ULNRC-787

DOCKET NUMBER 50-483
CALLAWAY PLANT, UNIT 1
CALLAWAY PLANT TECHNICAL SPECIFICATIONS - APPEALS

Attachments: 1) Specification 3/4 6.1.6 and justification
2) Specification 3/4 4.9.3 and justification
3) Specification 3/4 6.3 and justification

FIGURE 3.4-4

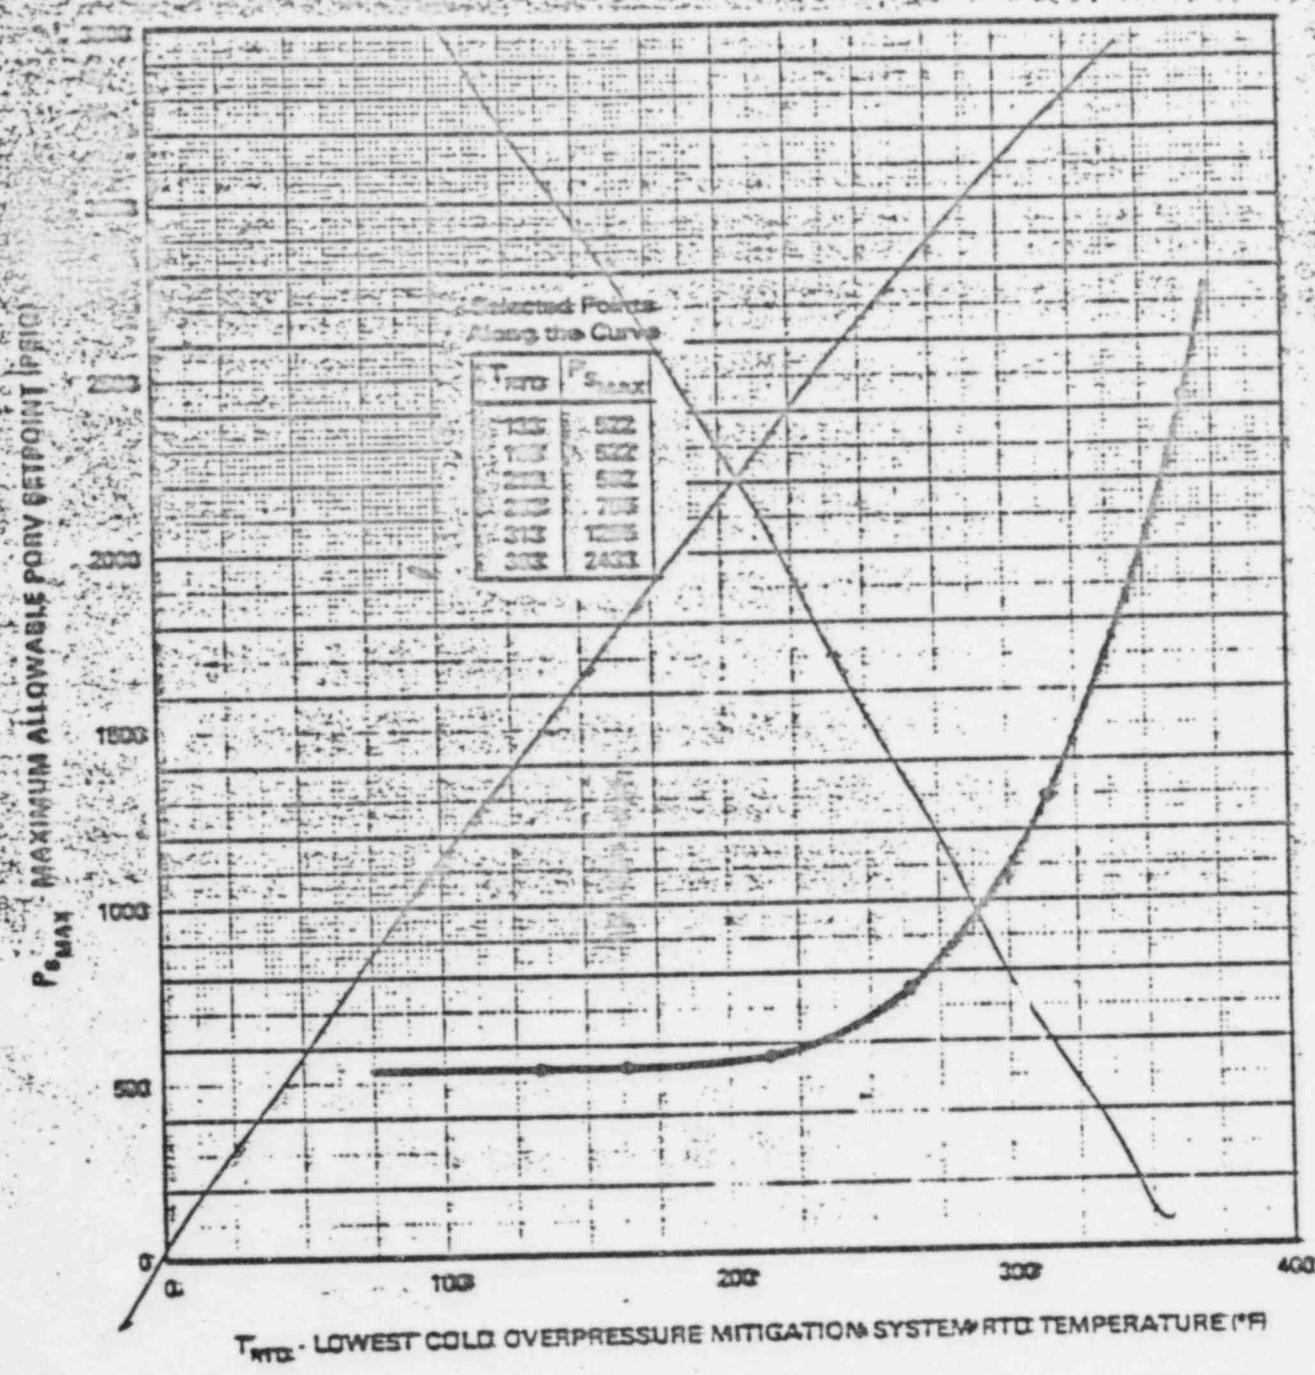
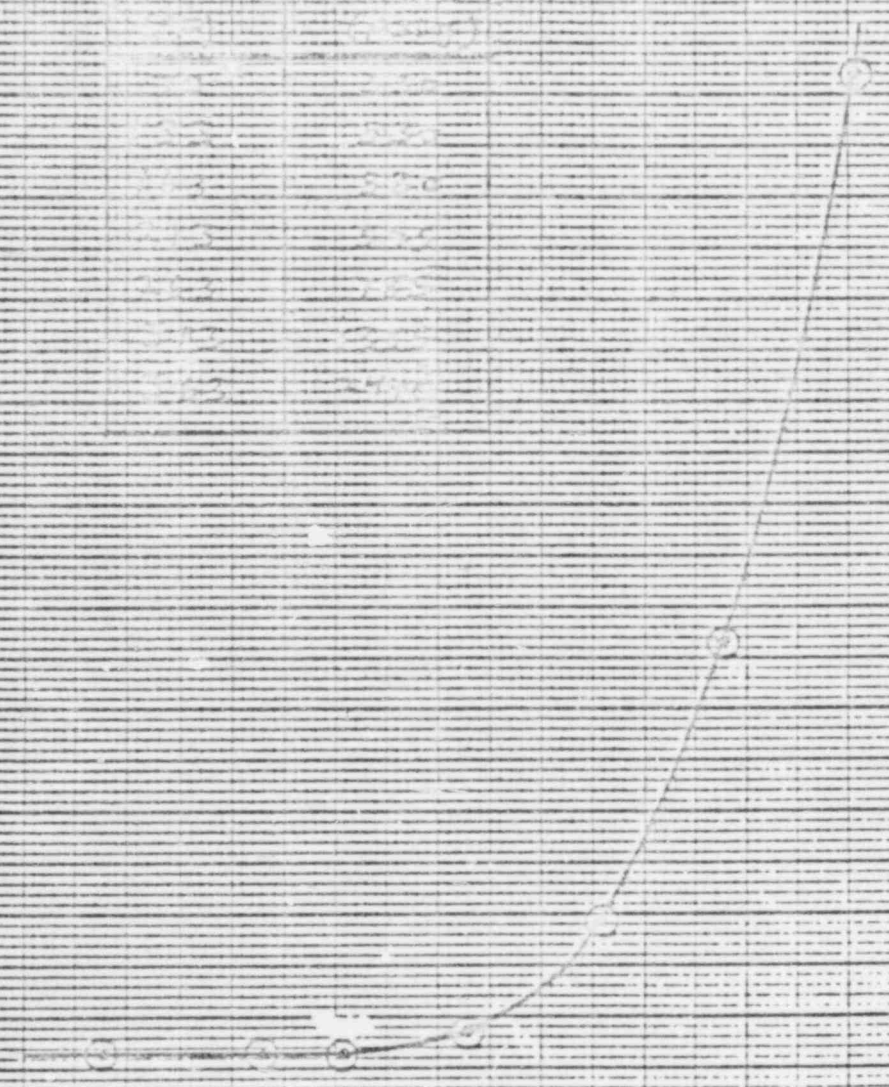
- b. Two power-operated relief valves (PORVs) with Setpoints which do not exceed the limit established in Figure 3.4-4, or
- c. The Reactor Coolant System (RCS) depressurized with an RCS vent of greater than or equal to 2 square inches.
